AGENDA
PLANNING COMMISSION
116 WEST NEEDLES
BIXBY, OKLAHOMA
November 19, 2012 **6:00 PM**

To: Bixby Planning Commission
From: Erik Enyart, AICP, City Planner *EE*
Date: Friday, November 09, 2012
RE: Report and Recommendations for:
PUD 73 – Eagle SPE Multi I, Inc. – Rosenbaum Consulting, LLC

To: Bixby Planning Commission
From: Erik Enyart, AICP, City Planner 
Date: Friday, November 09, 2012
RE: Report and Recommendations for:
Preliminary Plat (Resubmitted) & Final Plat of "Seven Lakes II"

Conceptual Site Plan

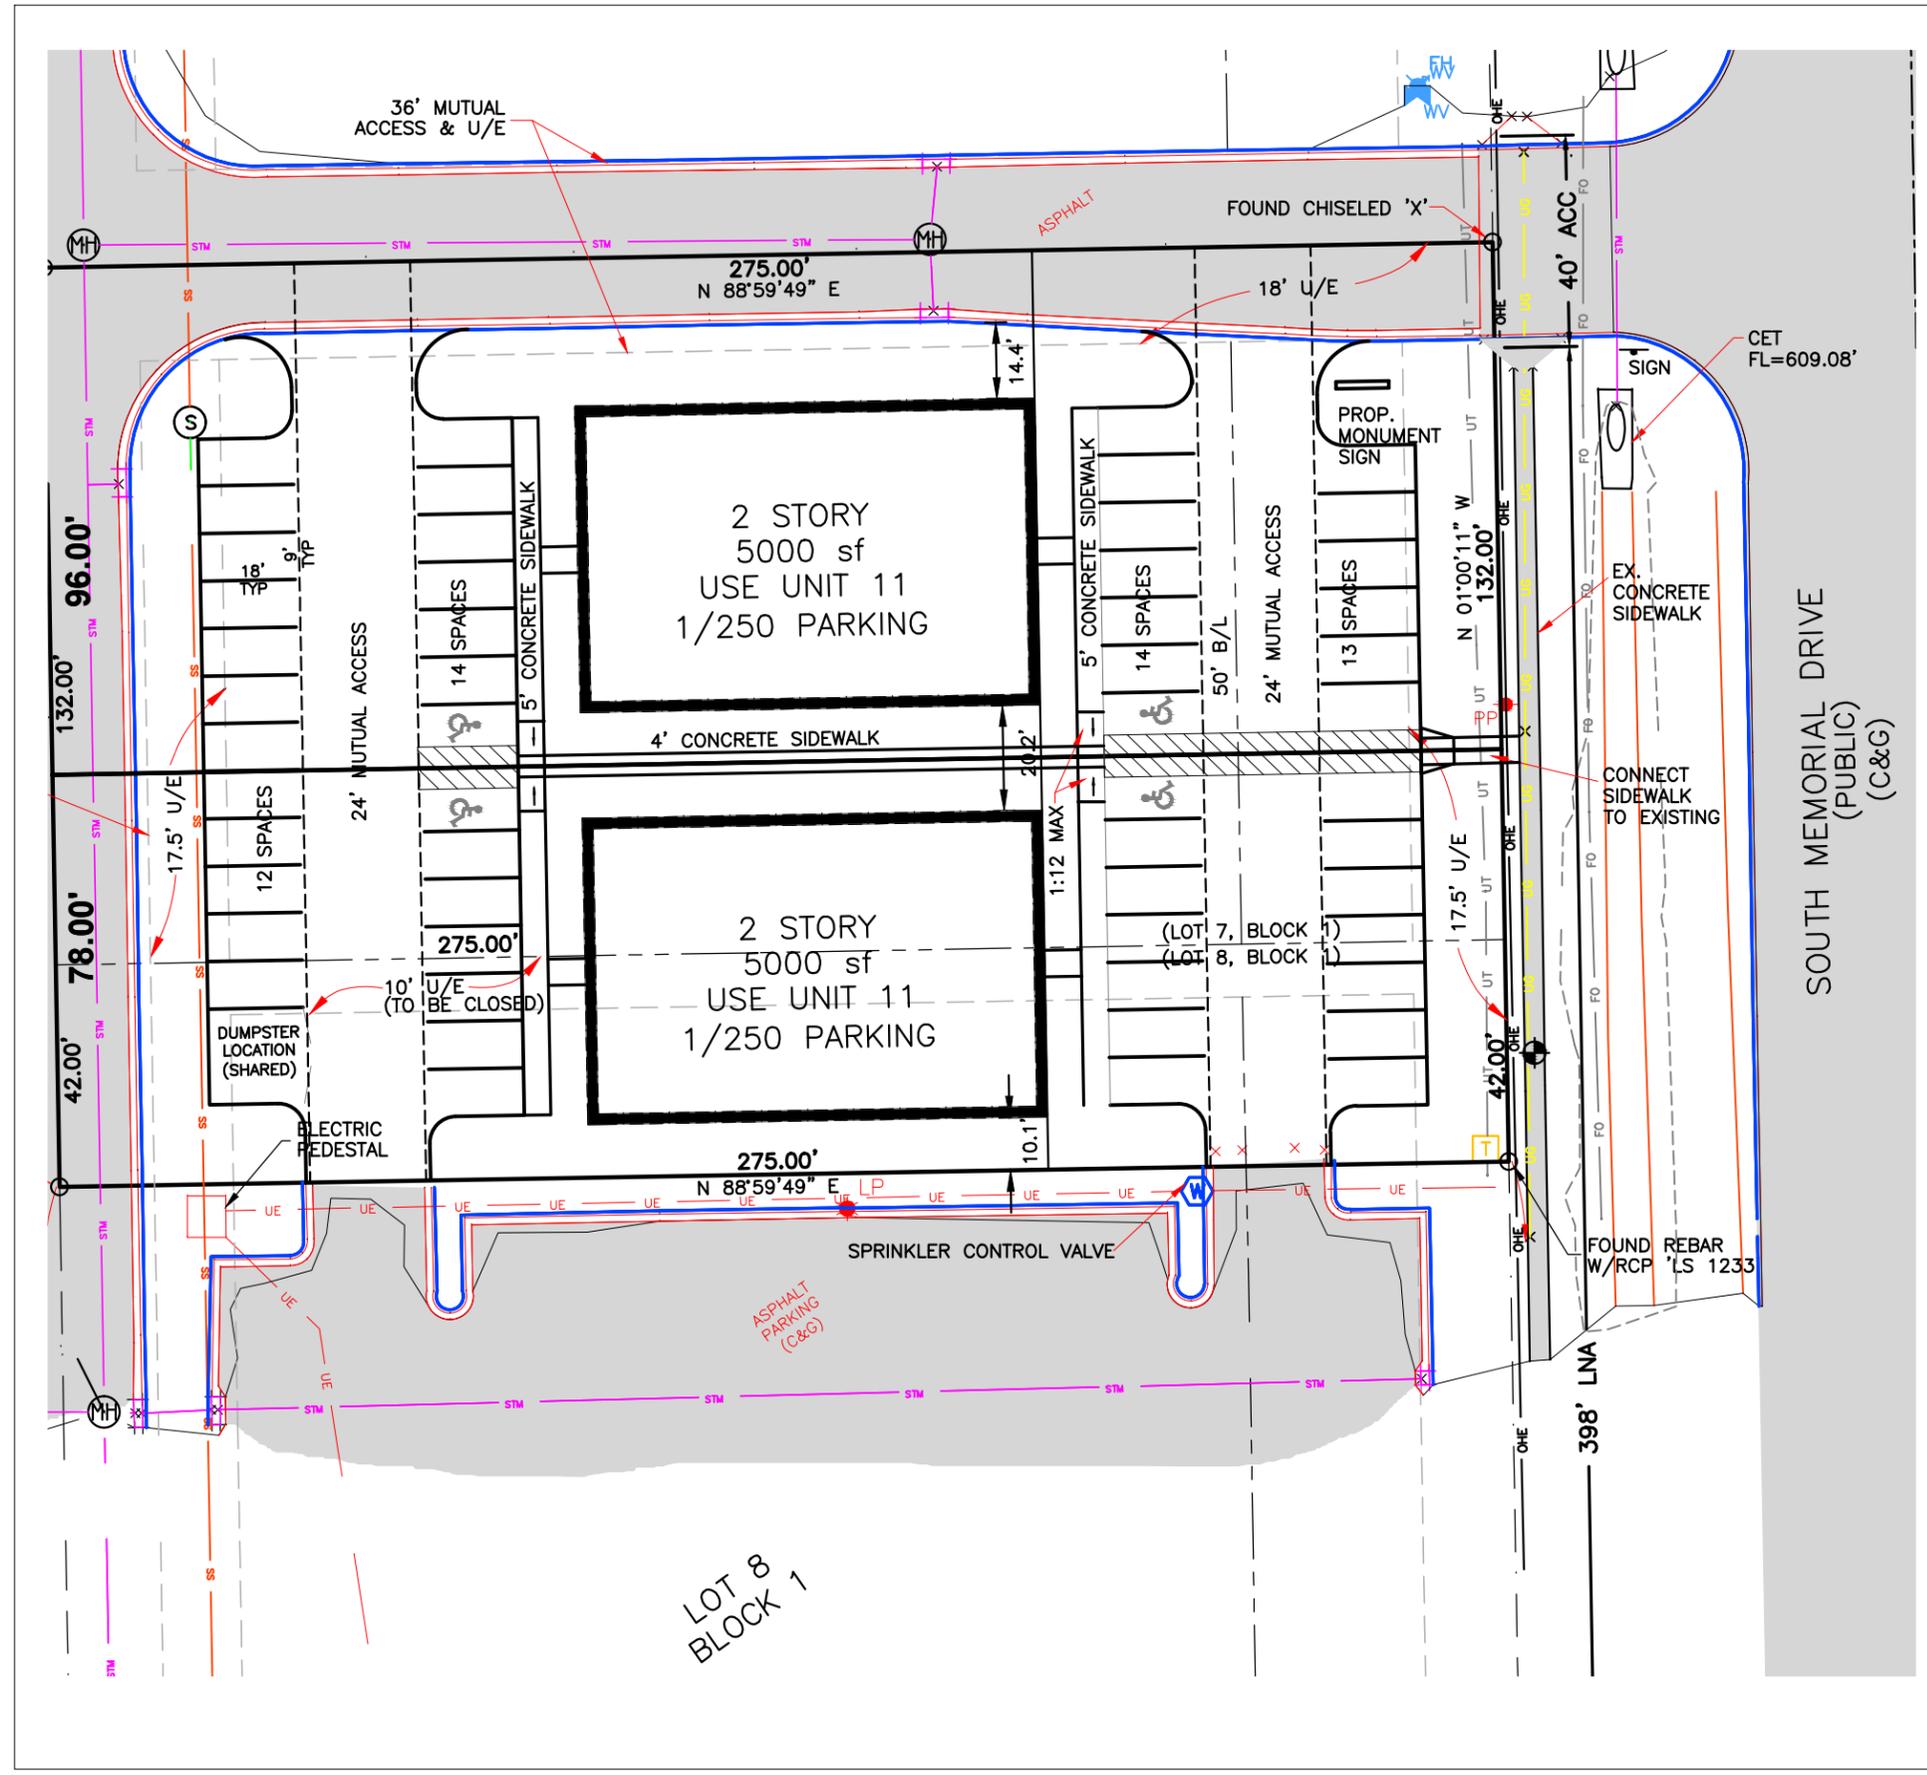
9. The following corrections or enhancements should be made to the Exhibit 1 Conceptual Site Plan:
 - a. Please dimension the building footprints.
 - b. Please use arrows to clarify the extent of the “24' Mutual Access” designations.

- f. The plans indicate parking lot paving will encroach the 17.5' U/E along the east and west property lines. Paving over easements requires the specific approval of the City Engineer and Public Works Director. Please adjust if/as required.

- g. Drive widths and particulars must be approved by the Fire Marshal and City Engineer. Please adjust if/as required.
- h. The four (4) handicapped-accessible parking spaces (1 per parking lot area per lot) appears consistent with ADA requirements in terms of number at a 1:25 ratio. Per the Building Inspector, the ADA guidelines require one (1) van-accessible design for the handicapped-accessible space, for up to seven (7) accessible spaces. Please indicate which spaces will be of van-accessible design in compliance with ADA standards and please provide a detail diagram demonstrating compliance with applicable standards, including both ADA and Bixby Zoning Code standards (see striping standards of Figure 3 in Section 11-10-4.C). The designer should consult with the Building Inspector to confirm the plans will comply with ADA standards.

- i. The northwest corner of Lot 7 is cut off on the drawing – please restore.
- j. Please qualify “1/250 parking” notation with “minimum.”

Preliminary Plat Seven Lakes II

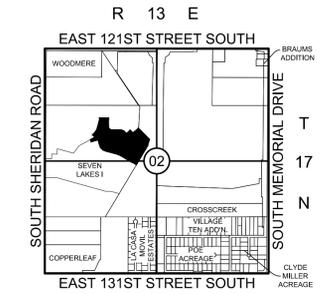
1. Subject to a Modification/Waiver from Subdivision Regulations Section 12-3-4.F, as Lot 15, Block 2, and Lot 7, Block 1 (and potentially others) appear to exceed the 2:1 maximum depth to width ratio as per SRs Section 12-3-4.F. The Modification/Waiver may be justified by citing its necessity as a product of an attractive subdivision design defined by the crisscrossing, curvilinear street network with no true cul-de-sacs, interspersed with Reserves for water amenities.

2. Subject to a Modification/Waiver from Subdivision Regulations Section 12-3-3.A, if any utility easements would not achieve the minimum width standards at 17.5' for perimeters. Such request may be justified by demonstrating where an 11' U/E will be back to back with another 11' in abutting subdivision, resulting in a 22'-wide U/E corridor between the subdivisions. Other justifications may be offered and deemed adequate.

7. As per an earlier version of this plat, the street connecting E. 125th St. S. to S. 71st E. Ave. was previously designated E. 124th Pl. S. Based on the provided addresses, S. 71st E. Ave. is implied. Depending on the future street network layout of the future phase of Seven Lakes immediately to the north, it may more appropriately be designated E. 124th Pl. S. or S. 71st E. Ave. For emergency 911 response, mail service, and general addressing purposes, please provide this street name and clearly differentiate street segments at the intersections. If to be E. 124th Pl. S., re-address the affected lots.

11. 25' B/L and U/E along all streets – is a full 25' needed? If not, consider a 20' U/E to provide a 5' buffer area, or the amount necessary to protect the integrity of the
